South Texas Project Electric Generating Station P.O. Box 289 Wadsworth, Texas 77483

December 10, 2003
NOC-AE-03001645
STI: 31679561
FILE NO: Z18
ER 20030053
10CFR50.4(b)(5)
10CFR50 App E

STP NUCLEAR OPERATING COMPANY
Units 1 and 2
Docket Nos. STN 50-498; STN 50-499
Changes to Emergency Plan Procedures

In accordance with 10CFR50.4(b)(5) and 10CFR50, Appendix E, Section V, the STP Nuclear Operating Company hereby submits the attached Emergency Plan and Implementing Procedure revisions.

**FIGURE C-1
Page 1 of 1
ONSHIFT EMERGENCY RESPONSE ORGANIZATION**

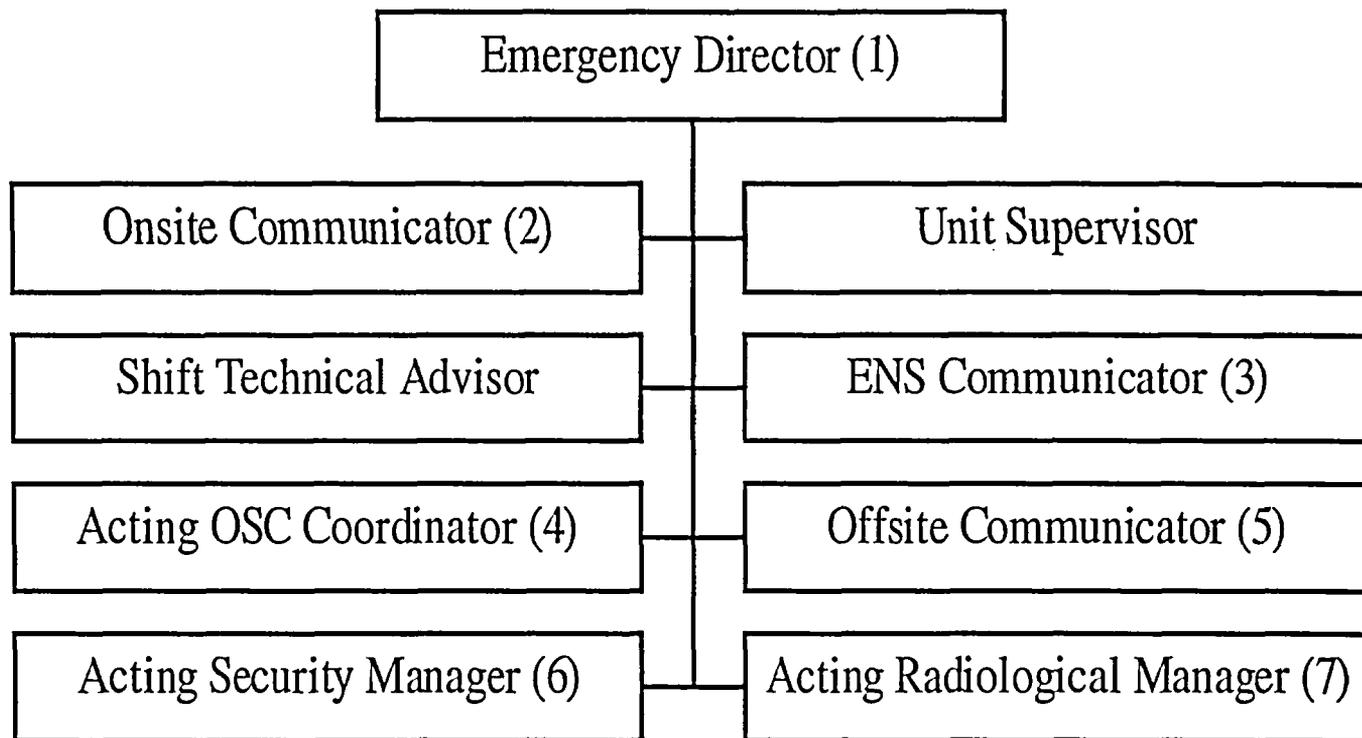
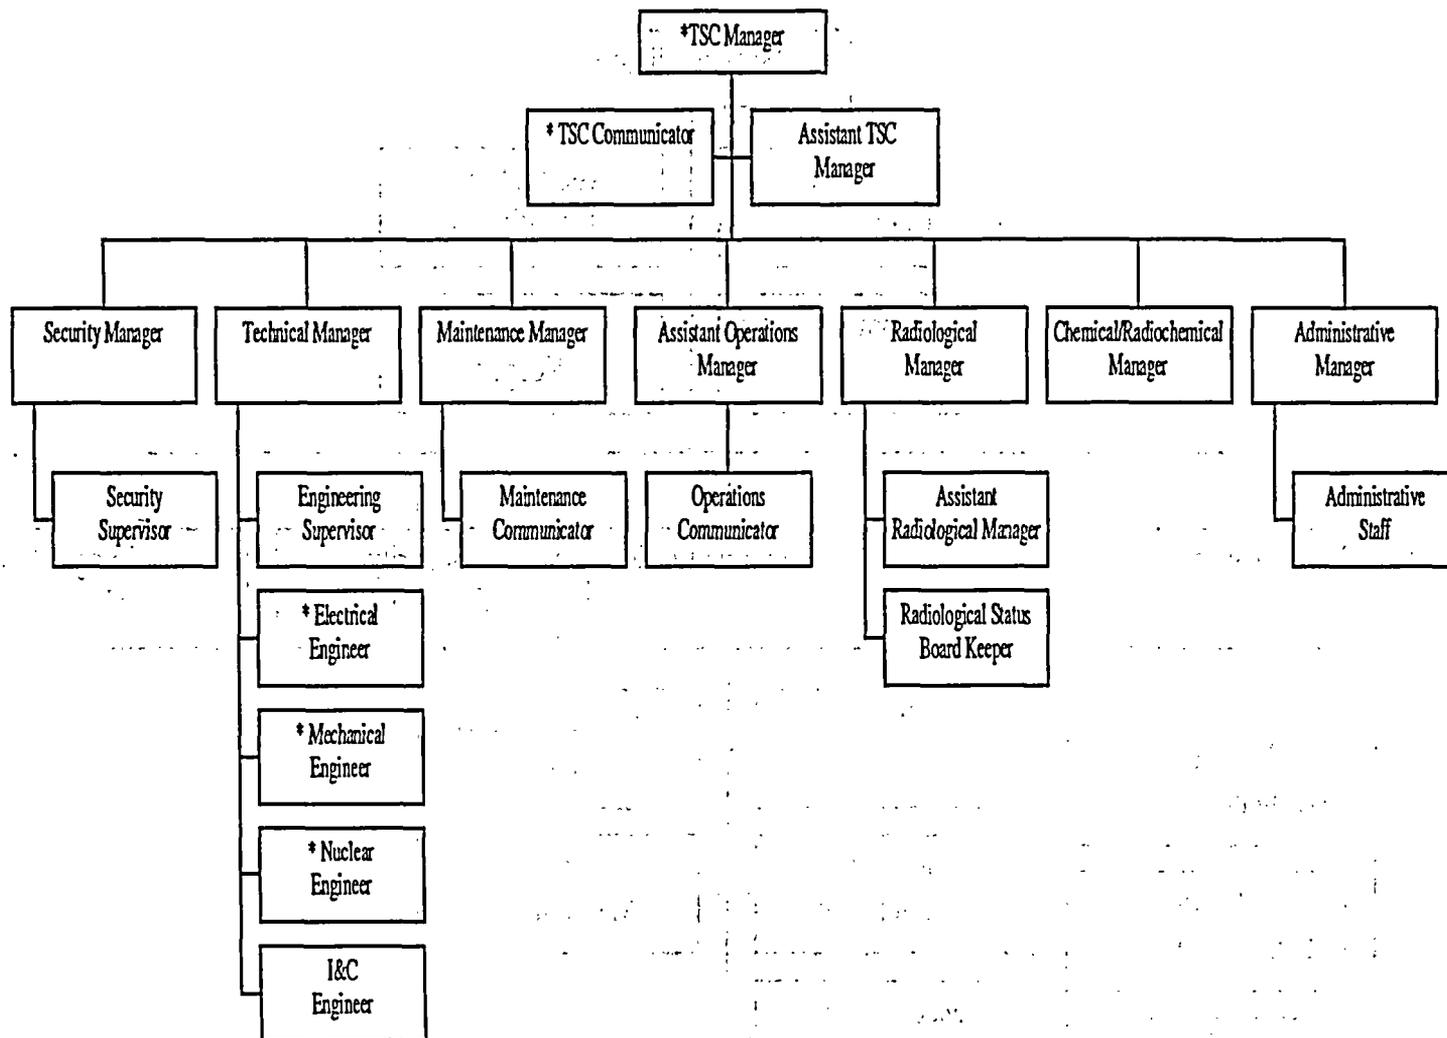
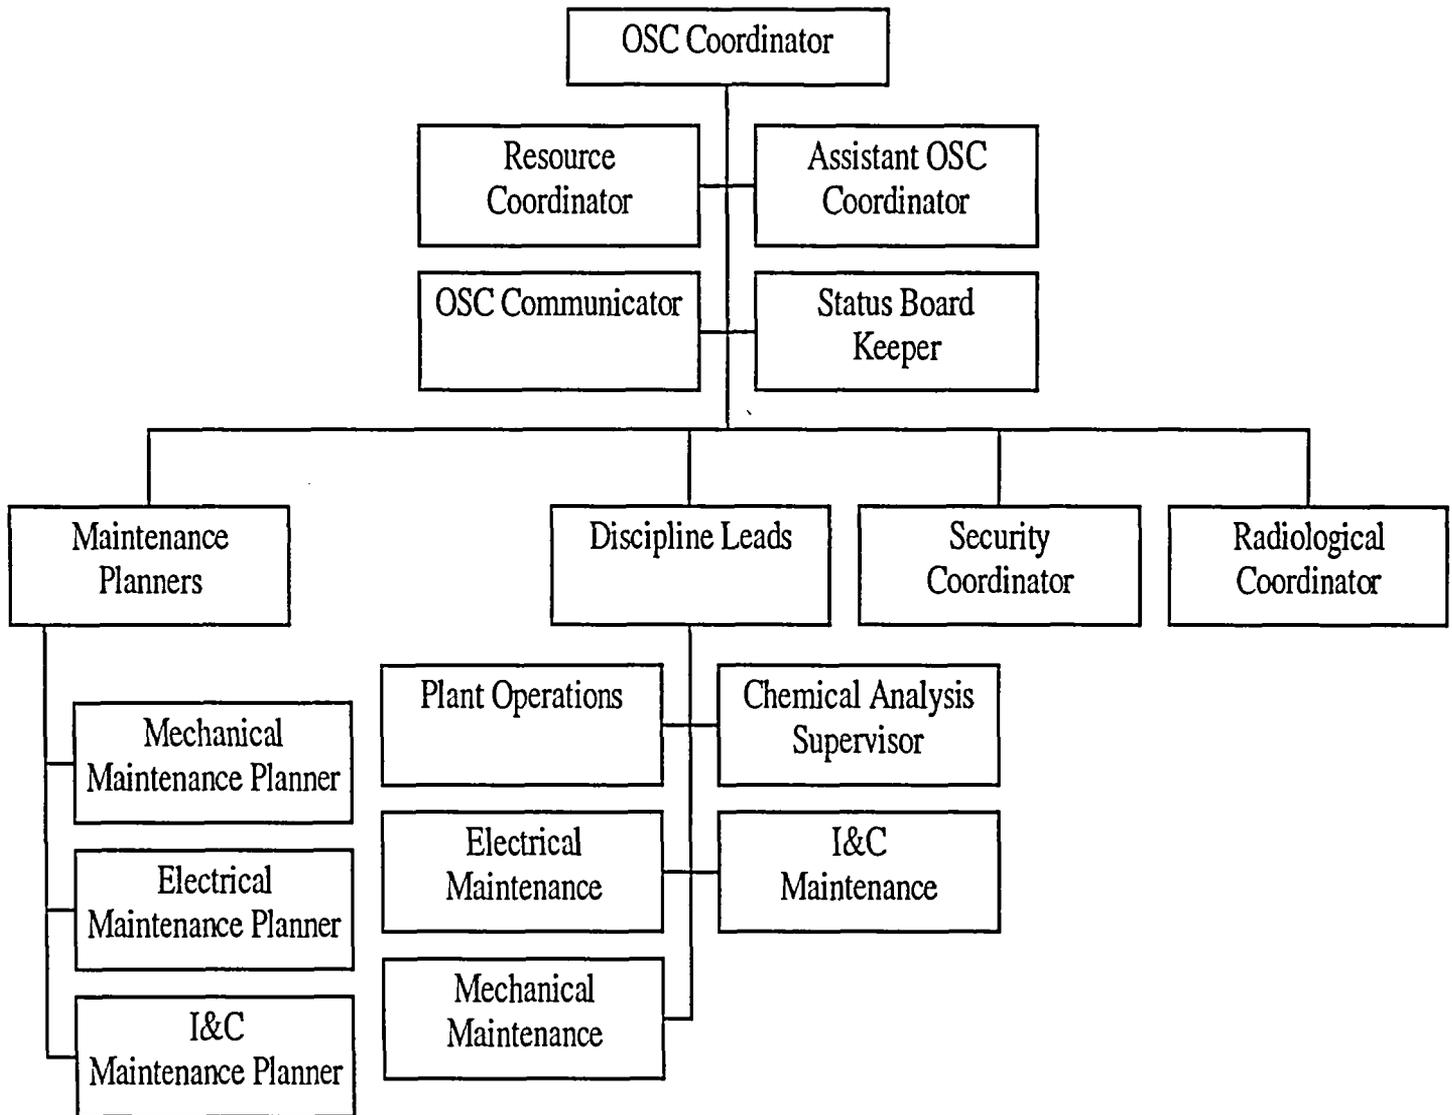
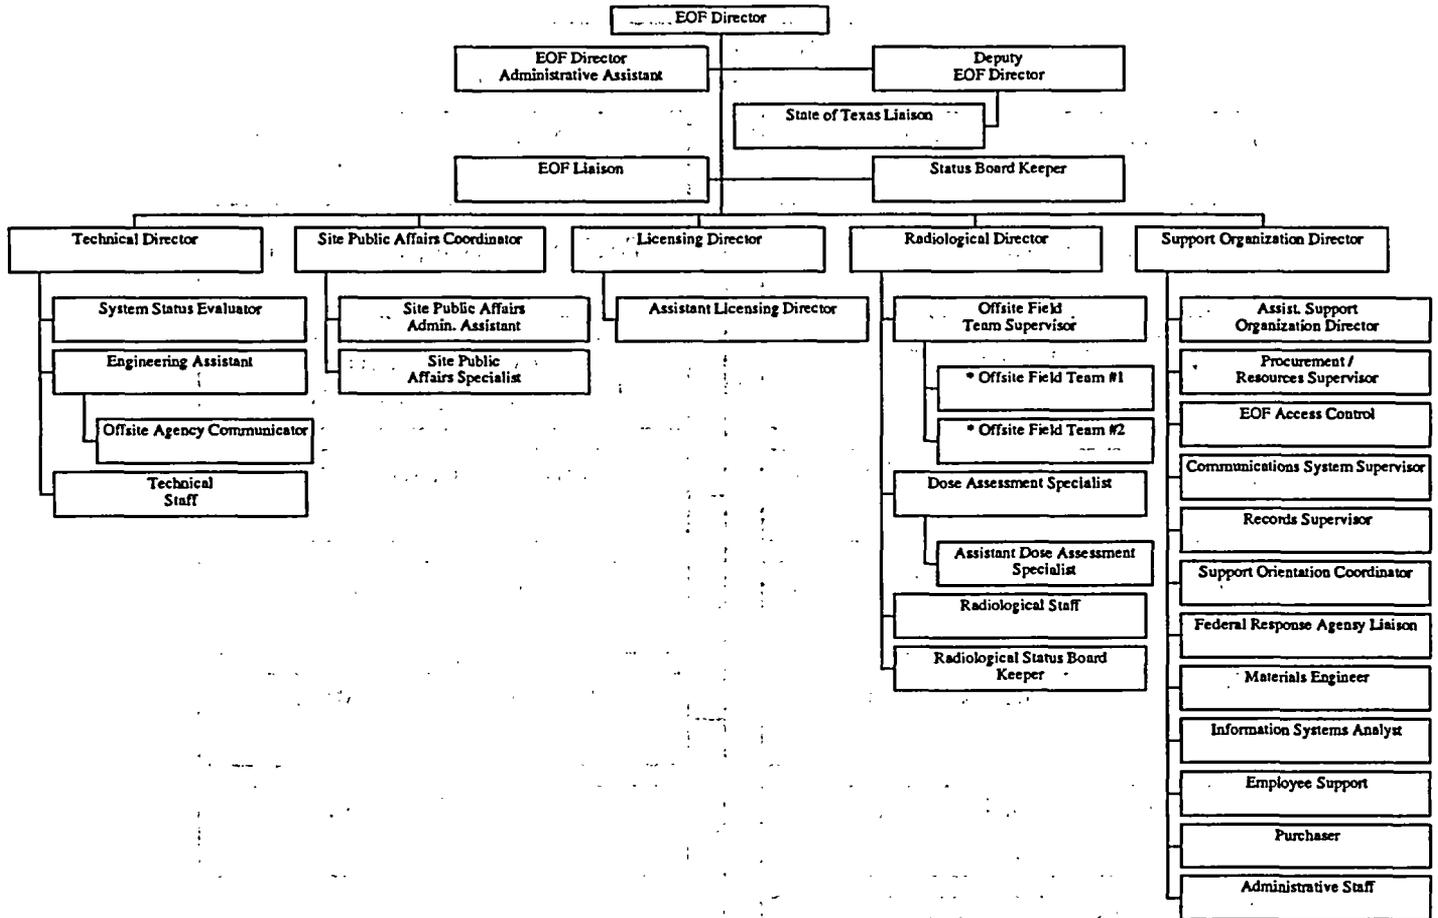
NO	CHANGE	REASON
7	Section C, Figure C-1 through C-4, pages 16-19, revised to look like staffing boards in the facilities	Editorial Clarification, no title changes
8	Section C, Figure C-5, page 20, renamed one of admin staff Communications Technician in the JIC	Clarification, individuals were already part of the Staff
9	Section E, step E.3, page 4, Added not to exceed four months	Missing Appendix E requirement
10	Section E, Figure E-1, Siren Locations	Changed siren IDs from letter to number codes.
11	Section E, New Figure E-3, Added titles for those in charge at both ends of communication links	Missing Appendix E requirement
12	Section G, step G.7, page 6, changes State Emergency Operations Center to State Operations Center	Editorial, Facility name change
13	Section G, step G.11, page 8, Added location of first aid station	Missing Appendix E requirement
14	Section I, page 4, revised 10-mile EPZ Map	Road # typo

0ERP01-ZV-OF02	Rev. 5	Page 21 of 25
Joint Information Center Activation, Operation, and Deactivation			
Addendum 4	Joint Information Center Floor Plan (Sample)	Page 4 of 7

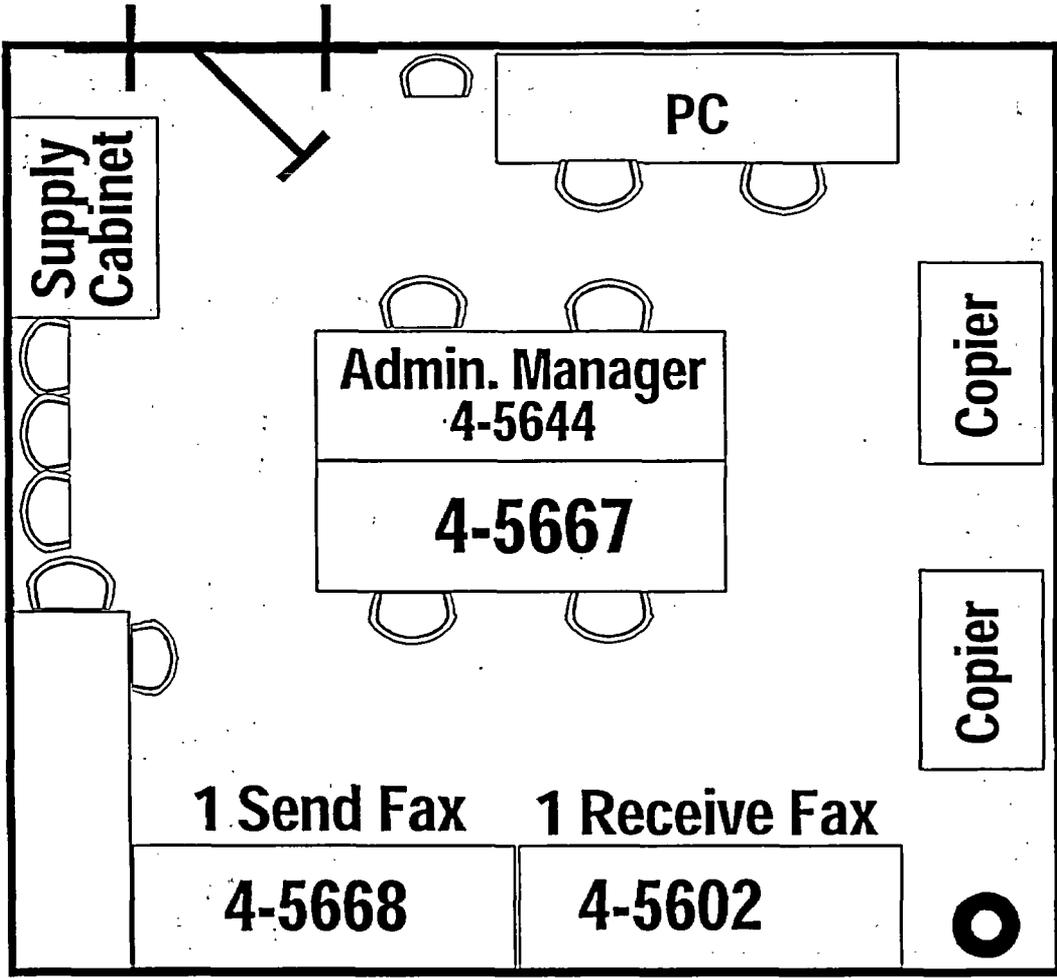
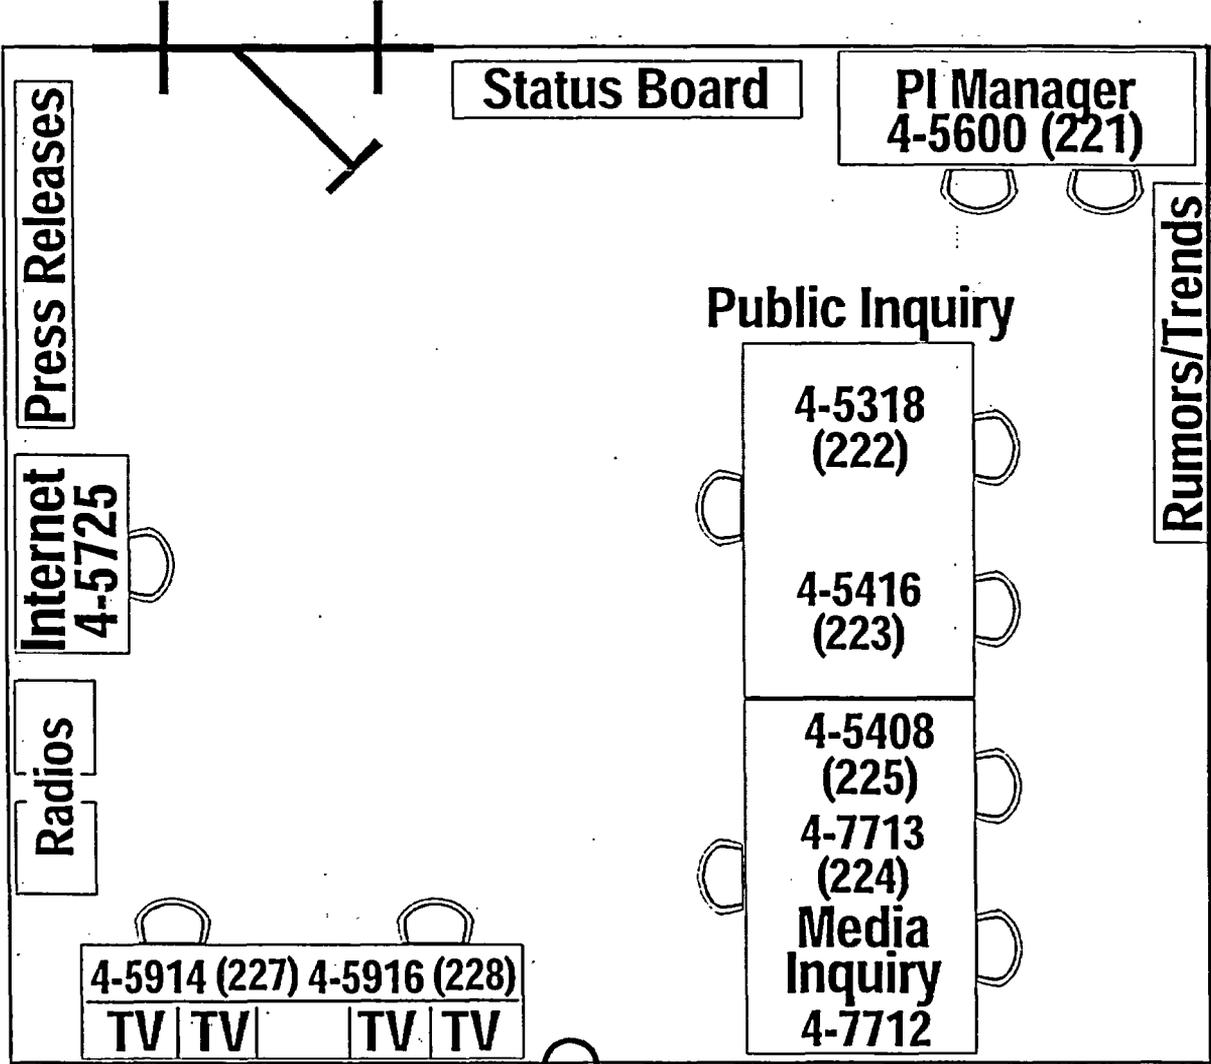
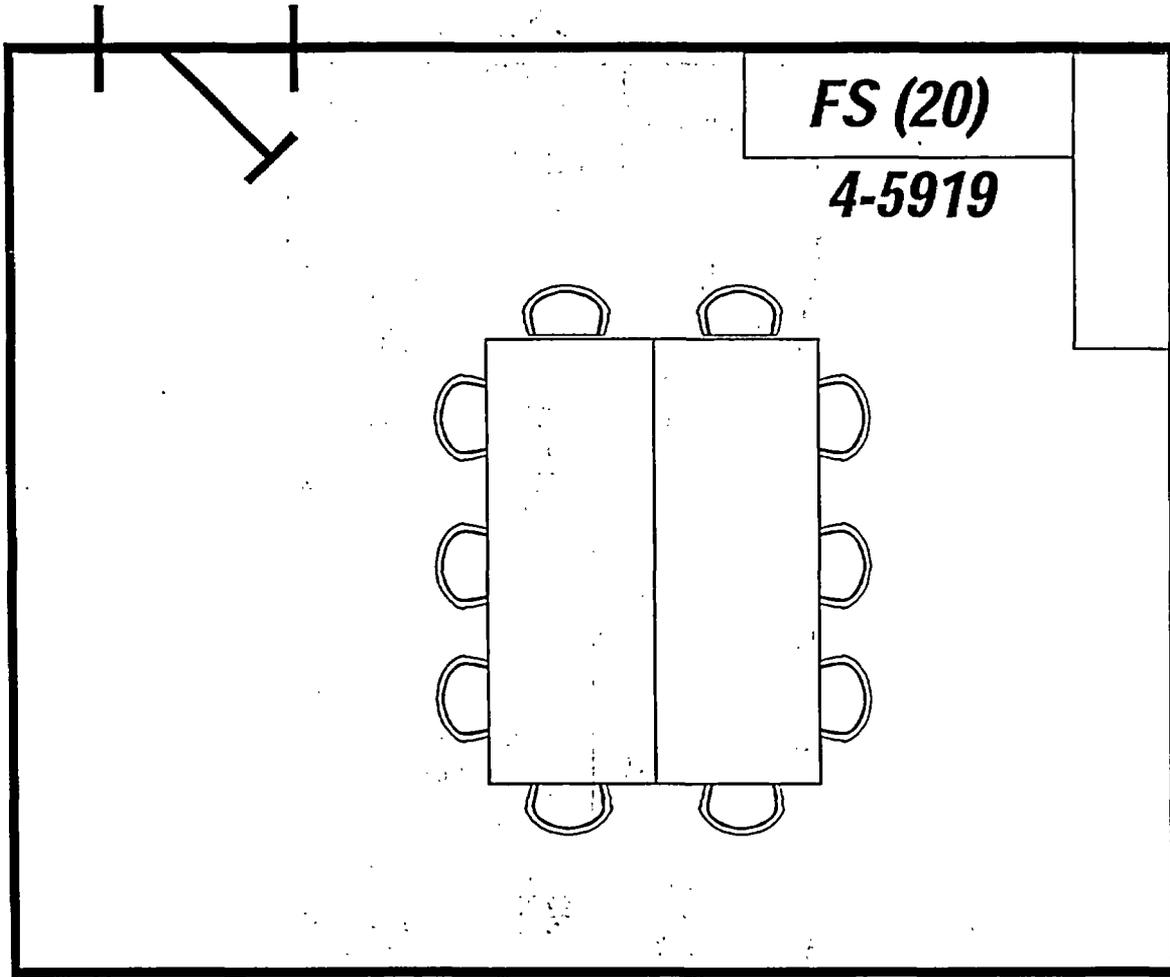
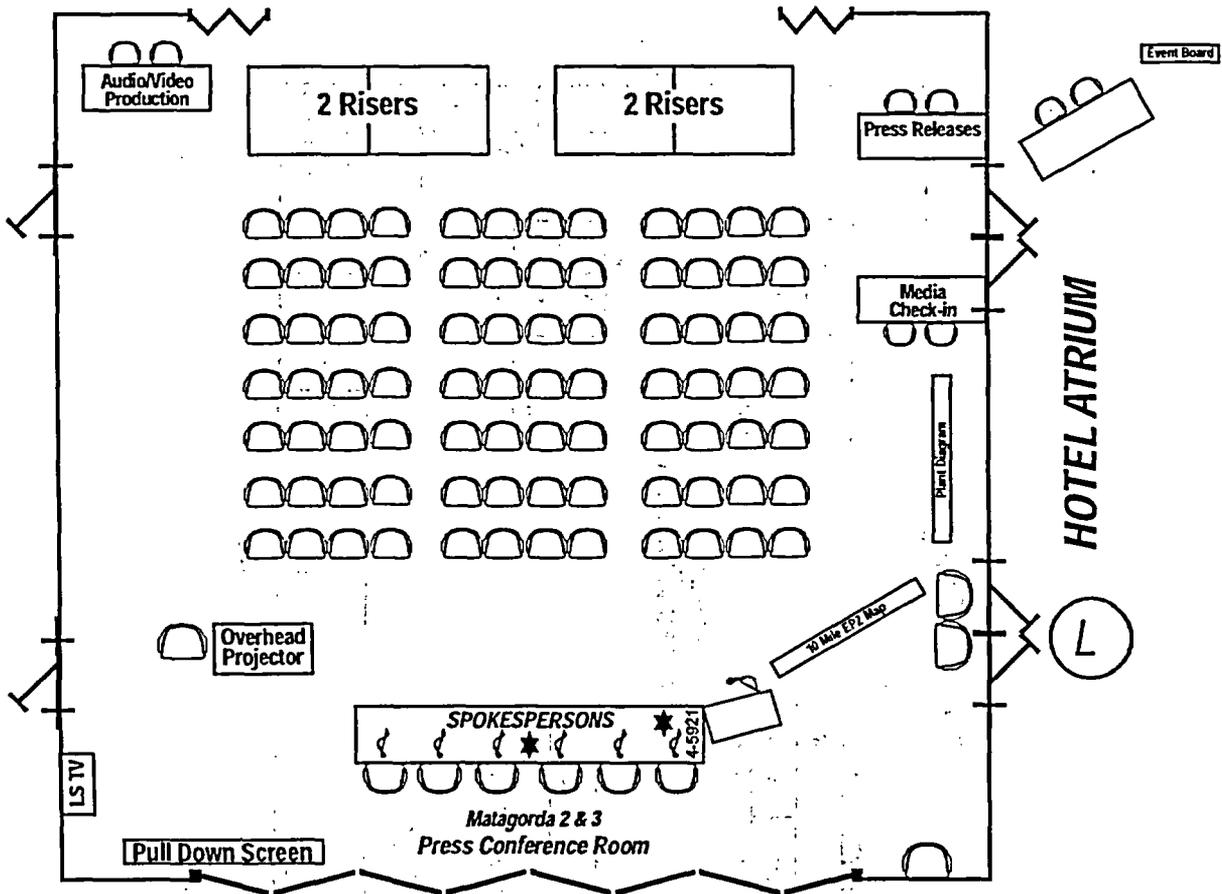
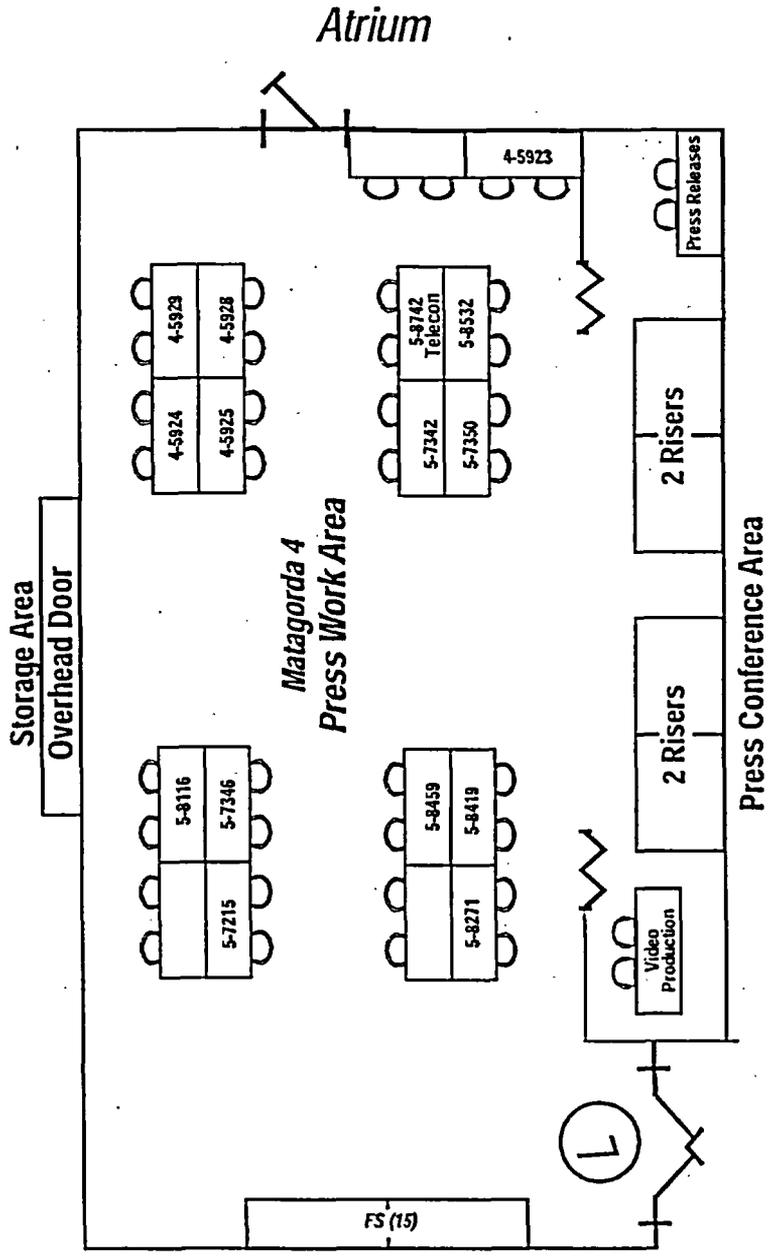
NO	CHANGE	REASON
18	Addendum 4, made minor changes to JIC layout drawings – removed most telephones from the center table in the Spokesperson Work Area room, added additional isles in the Press Conference room and deleted several rows of chairs and added Polycom, changed name of Rumor Control in Public Inquiry room to Public Inquiry, added teleconference to phone in Media Work Area that can be used for initial teleconference.	To reflect minor changes team has decided to make to the set up of the facility.
19	Added Addendum 5, JIC Priority set up.	During a drill, the team requested a JIC facility priority set up be provided in the procedure.
